RE: St. Lucie Unit 1  
Docket No. 50-335  
Neutron Shielding

ATTACHMENT

I. NRC QUESTIONS OF 4/29/77

II. RESPONSE TO 4/29/77 NRC QUESTIONS  
ON NEUTRON SHIELDING

OBE FL. SPECTRA VERT.

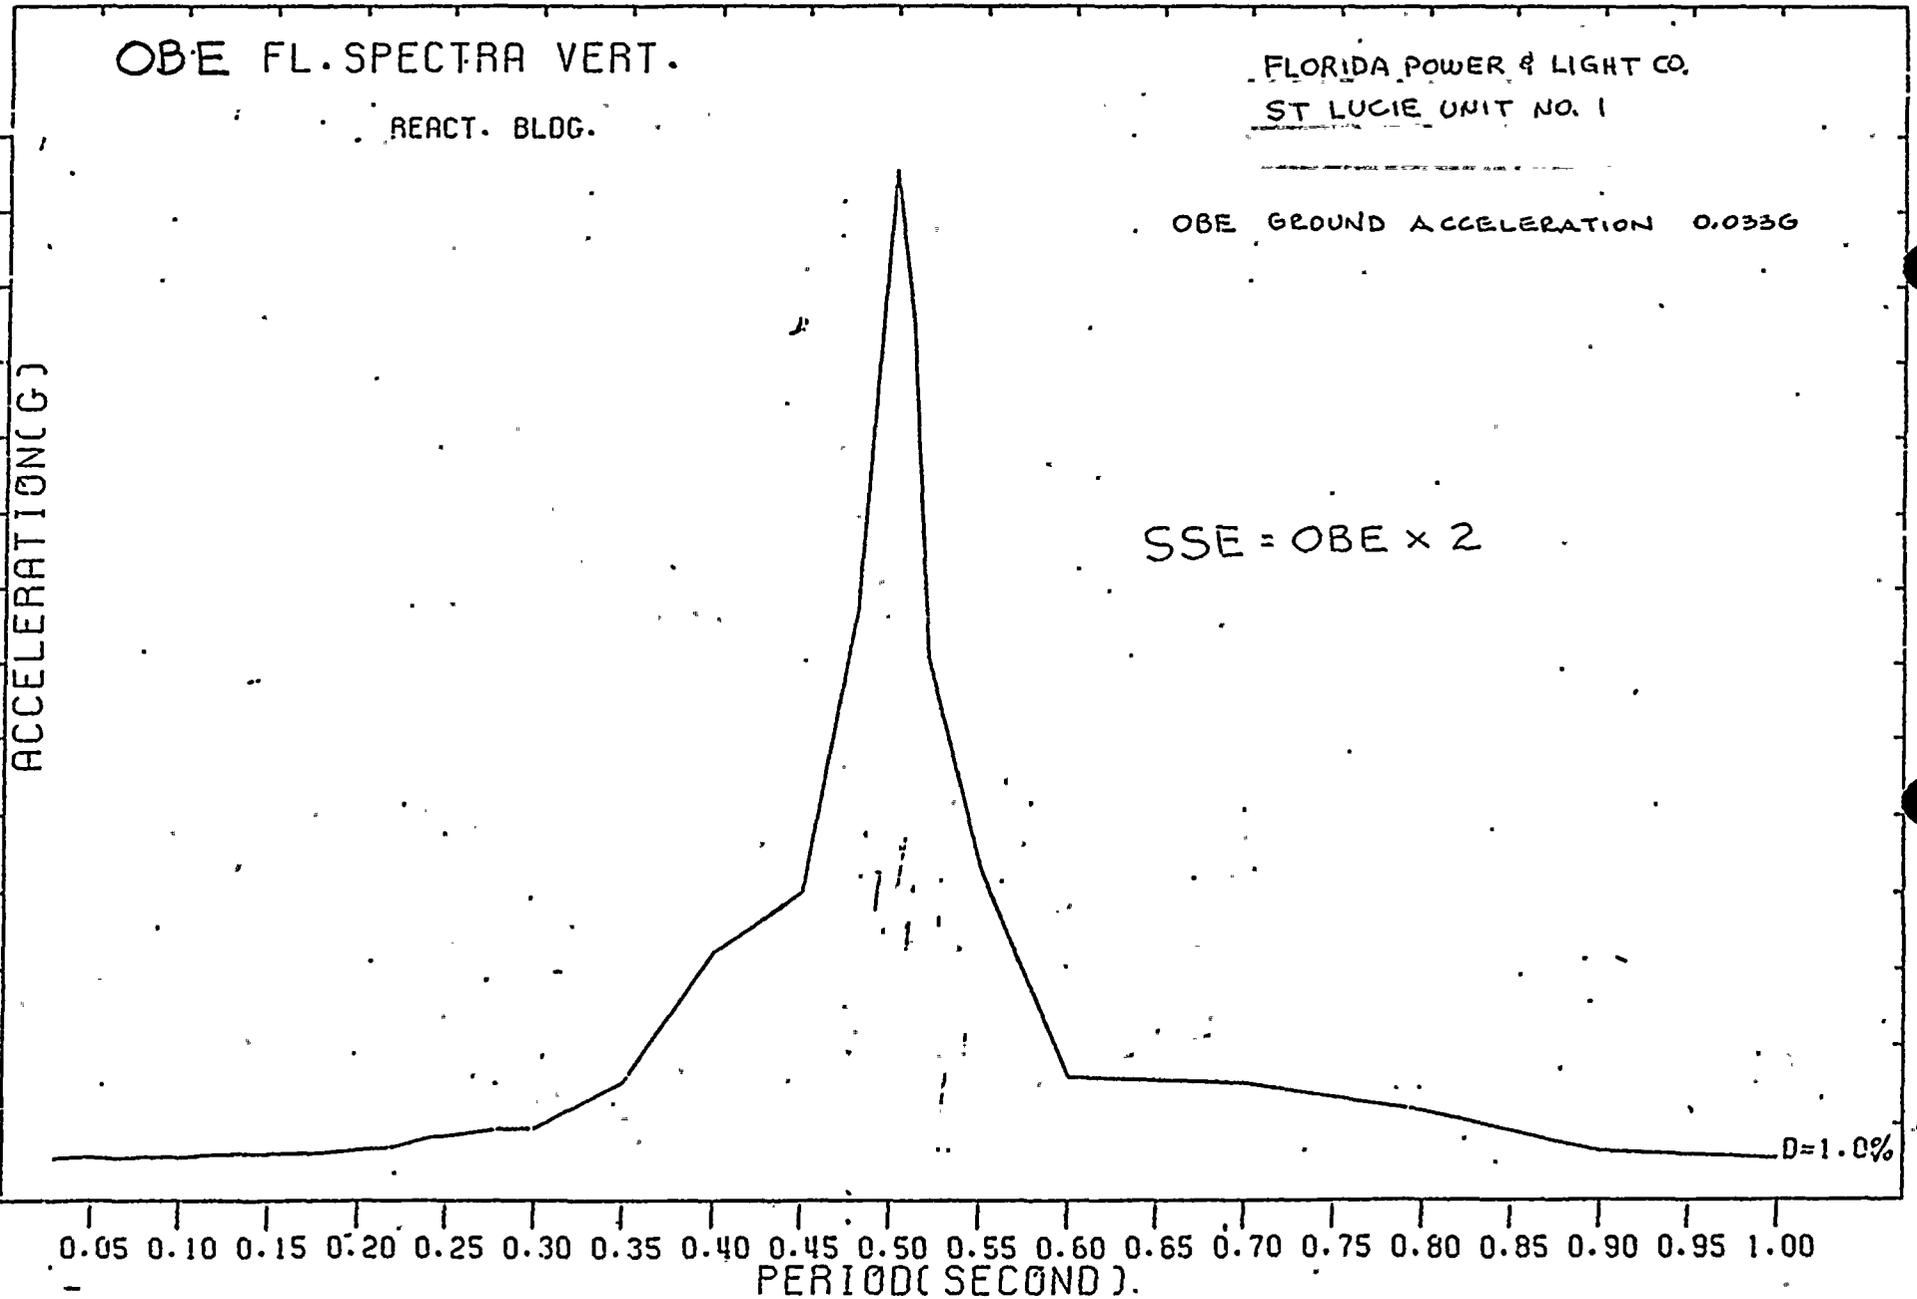
2. Clarify if the seismic excitation along three orthogonal directions was imposed simultaneously for the design of the shield support structure. The peak response from each direction may be combined by the square root of the sum of the squares (SRSS). Provide the vertical and two horizontal floor response spectra used in the analysis and describe the basis of their development.

2. The shield support structure design will consider seismic excitation along three orthogonal directions imposed simultaneously. The peak response from each direction will be combined by SRSS. Attached are the vertical and horizontal (OBE) response spectra used in the analysis. The vertical spectra curve applies to all elevations and was used at the support elevation. In the horizontal directions, spectra curves at the support elevation were not available, so the maximum "g" envelope of the curves from the next upper (El 44.00') and lower (El 24.00') elevation was used. At a given elevation, the same curve applies to both E-W and N-S horizontal directions. The magnitude of the DBE response is defined as twice that produced by OBE excitation. The basis of the development of the floor response spectra is described in FSAR Section 3.7.1.

FIGURE 18

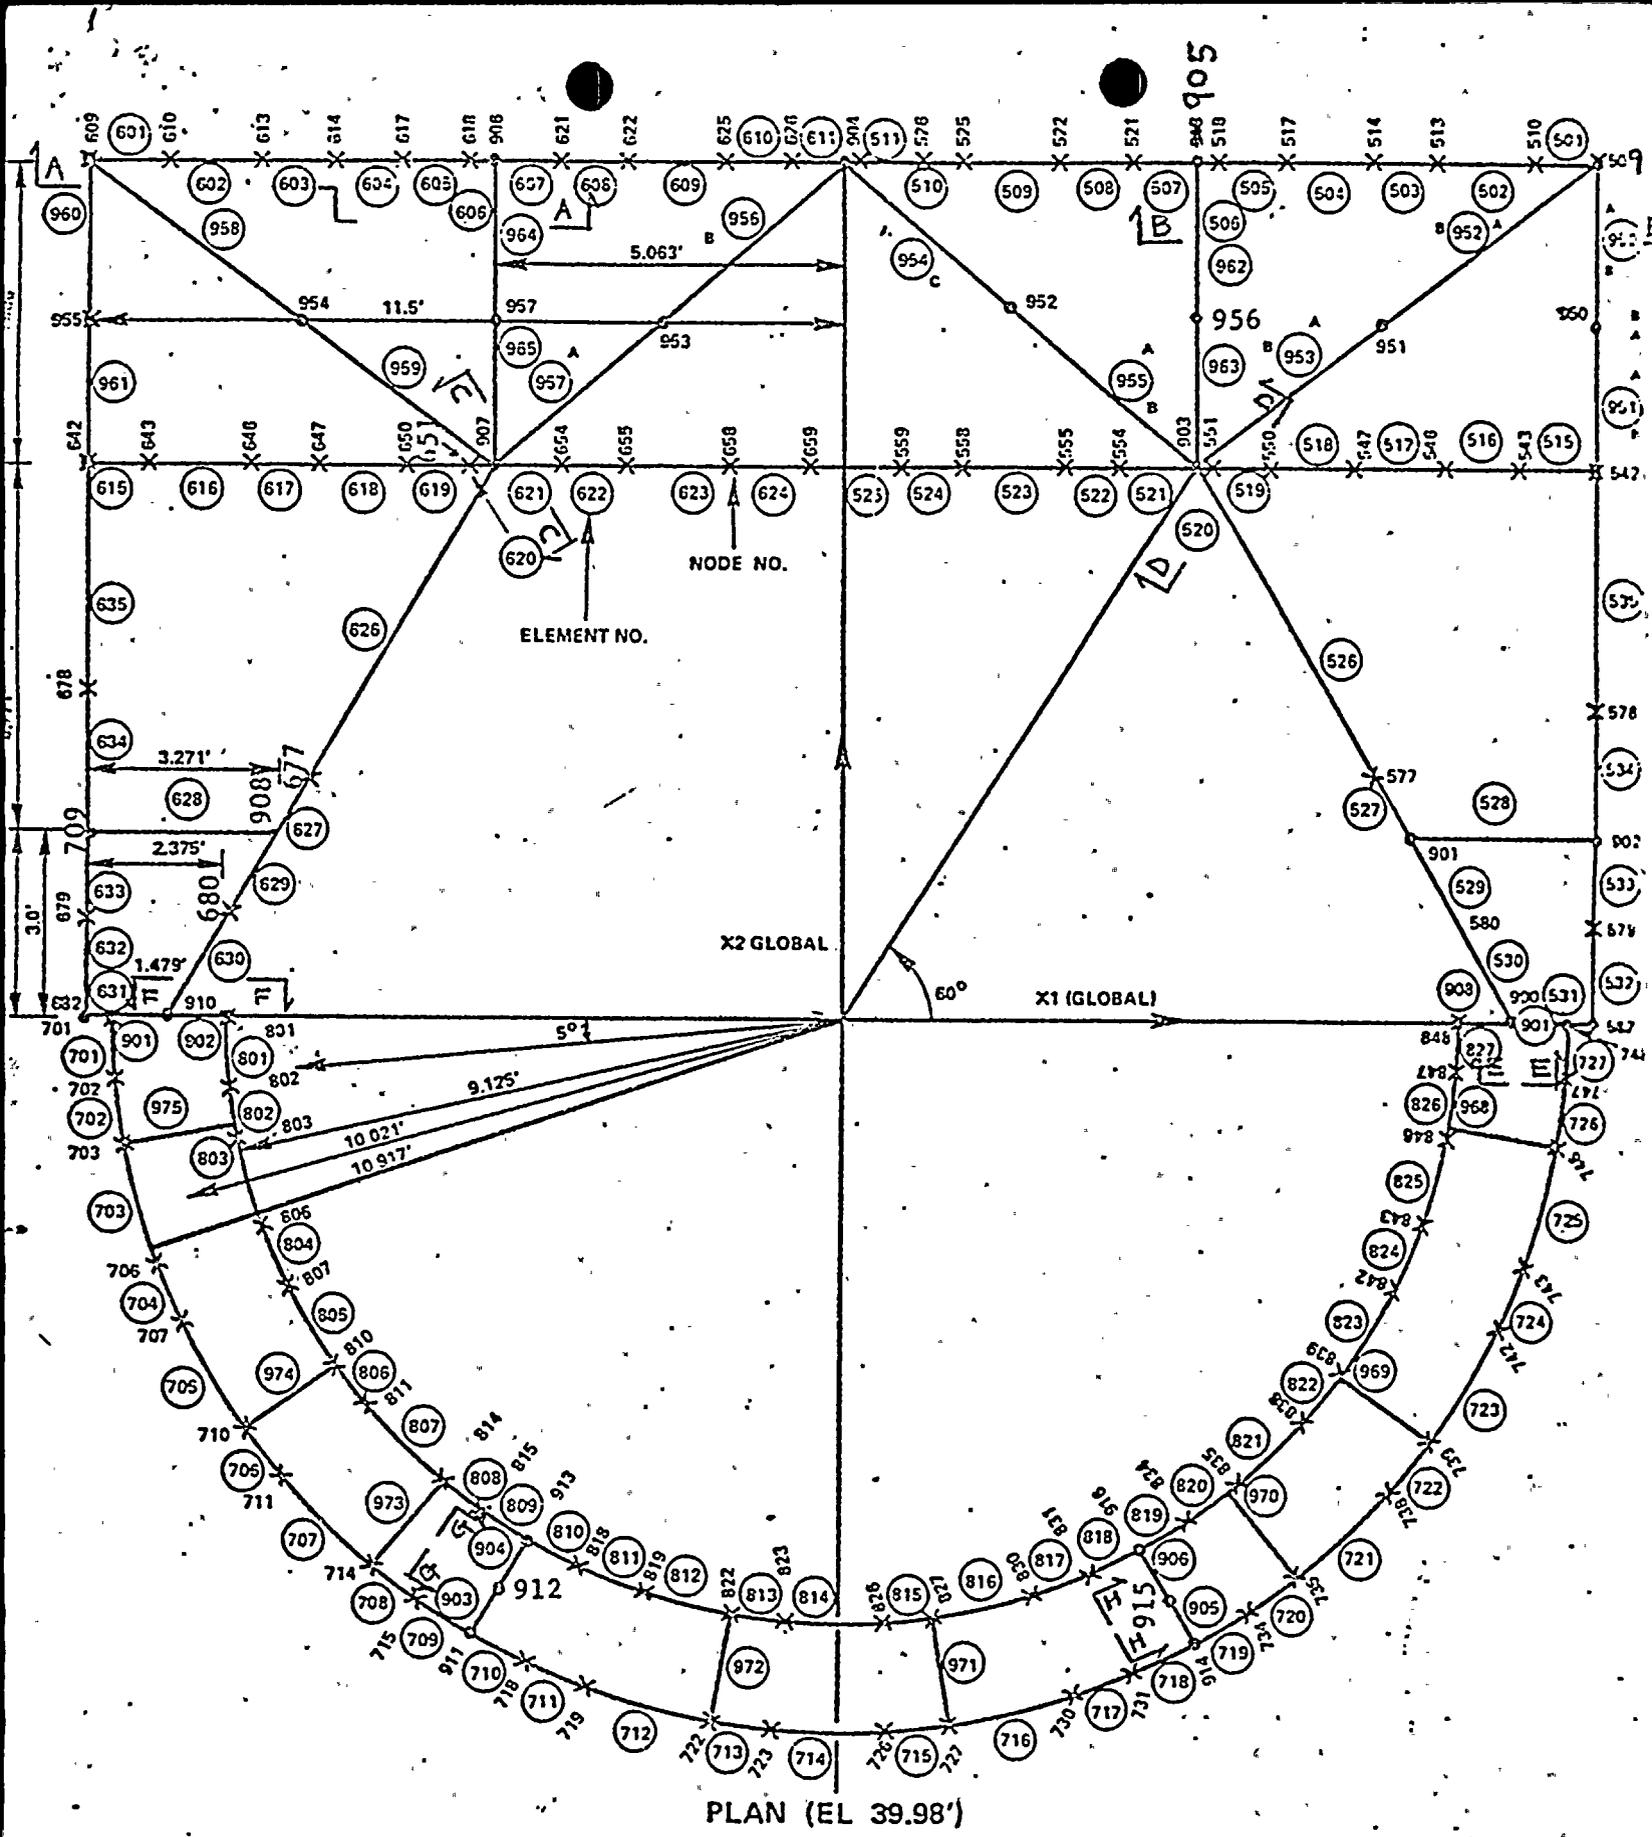
3. Provide clear and legible copies of Figures 1 and 2. You may send full size drawings directly to the NRC Project Manager. Also, clarify the location of the sections shown in Figure 19.

3. G-size prints of drawings SK-8770-AS-154 Sh 1 and 2 (Figures 1 and 2) have been transmitted to the NRC Project Manager, E. Reeves, under separate cover. Attached are marked-up copies of figures 18 and 19. The corrections shown on these figures will clarify the section locations.

Cross Sections

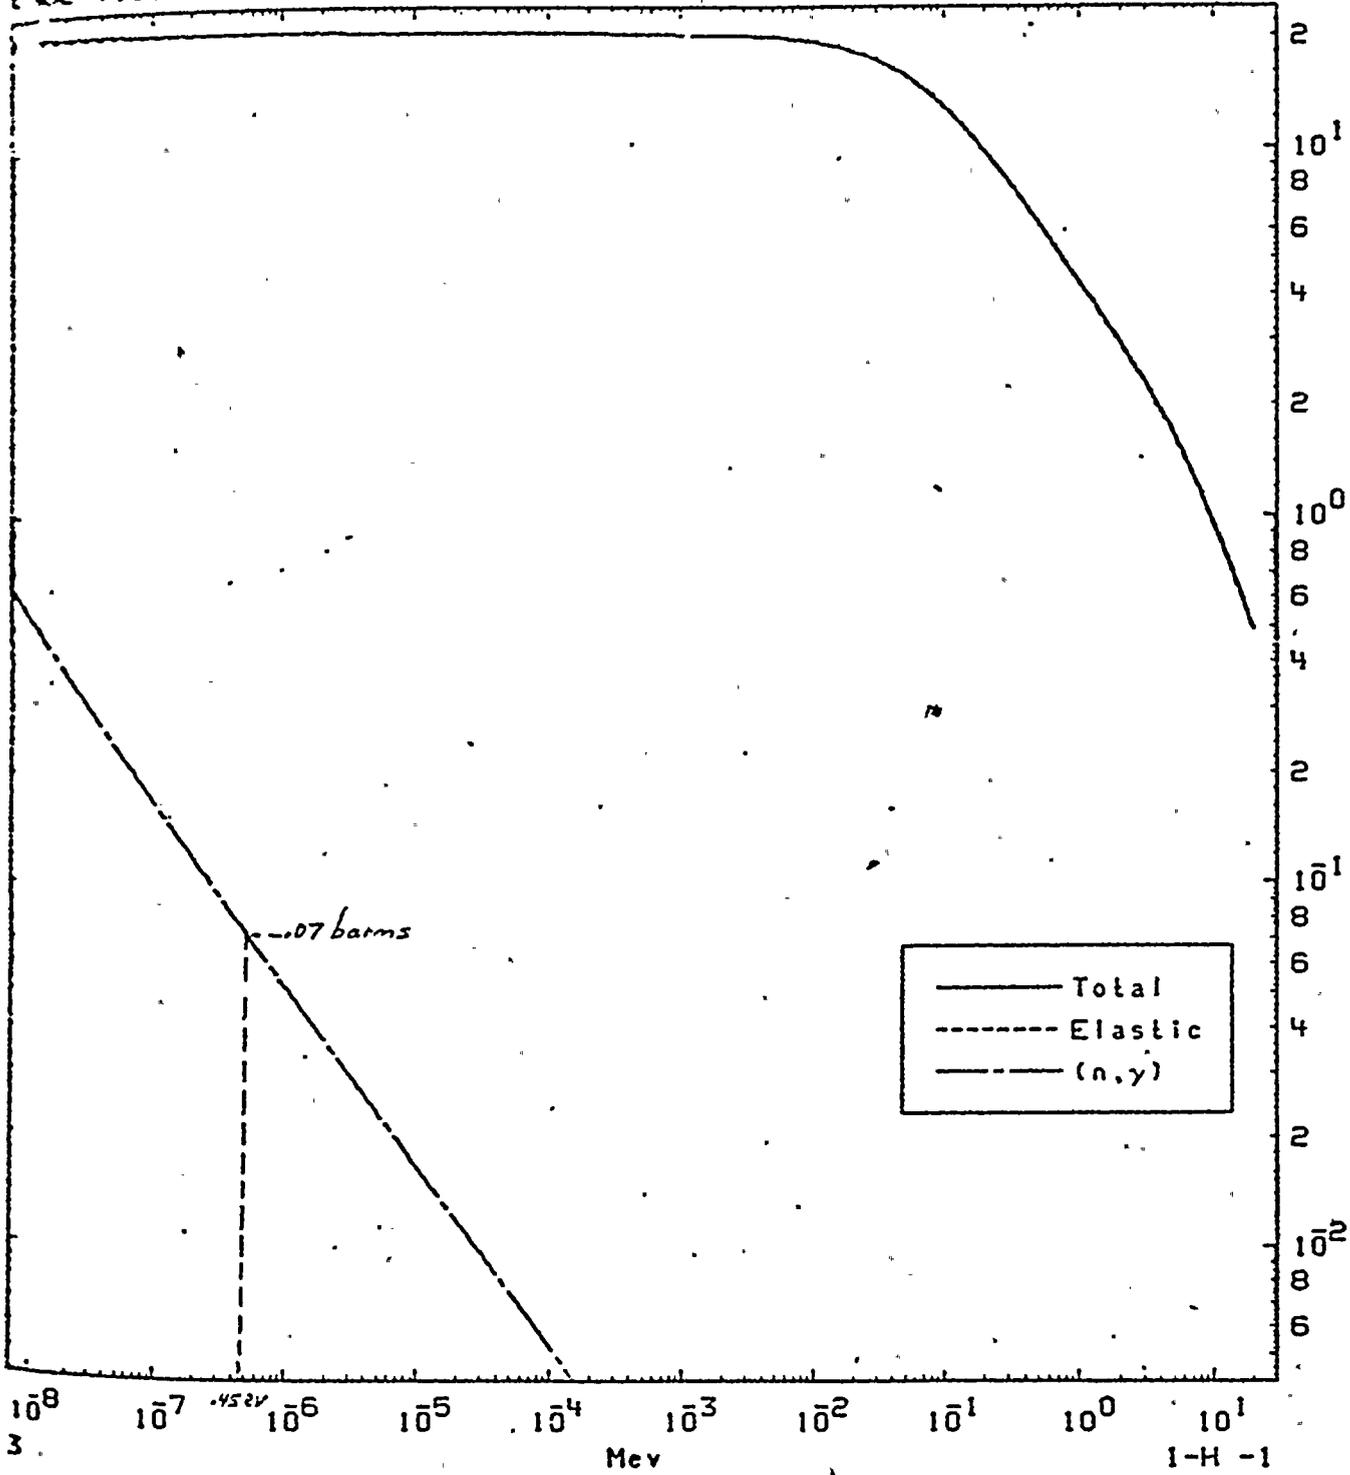
8. Provide an analysis of the exposure dose rate (mr/hr) evolved from 2.2 MEV neutron capture gamma-rays formed from neutron capture of the hydrogen in the water shield. The analysis should address the capture gamma-ray effects from all neutrons incident on the water shield including the incident thermal neutrons ( $10^7$  n/cm<sup>2</sup>-sec) and those fast neutrons interacting in the water shield that are eventually slowed down and captured.

The capture gamma source density is then computed utilizing a thermal capture cross section of 0.33 barns (see attached figure). Its value is  $1.1 \times 10^6$   $\gamma$ /cc sec.
